**Submission to the Department of Urban
Affairs and Planning**

**Draft Sydney Regional
Environmental Plan -
St Marys, the draft St Marys
Environmental Planning
Strategy, and the Outline
of the Proposed
Development Agreement.**

9 March, 2000.

Figure 4.0 Structure Plan showing potential fill area.

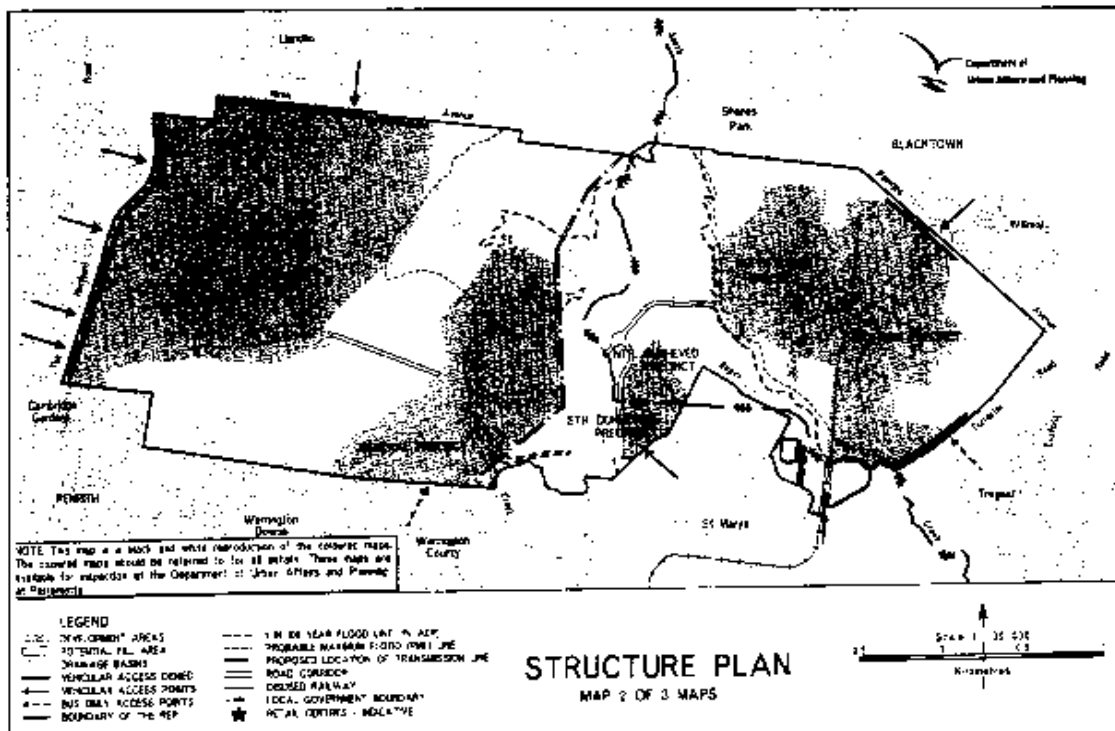
The 'potential fill area' shown in figure 4 below, is situated within the floodplain and has the potential to lead to substantial hydrological impacts within the catchment. Blacktown City Council has always opposed fill in the floodplain as documented in the s.22 Committee report. Apart from the environmental impacts on the hydrological regime and natural environment, liability issues would also need to be assessed and this has not been carried out to date.

Council does not allow general filling to occur on floodplains elsewhere in the LGA. The ADI proposal would therefore set an undesirable precedent in relation to this matter.

In relation to fill in the floodplain, Blacktown City Council re-iterates its opposition. Further, detailed soil, salinity and flood damage assessments should be conducted prior to any rezoning occurring, to avoid the situation whereby development expectation can not be met at the precinct plan or development application stage because of the impact of these issues.
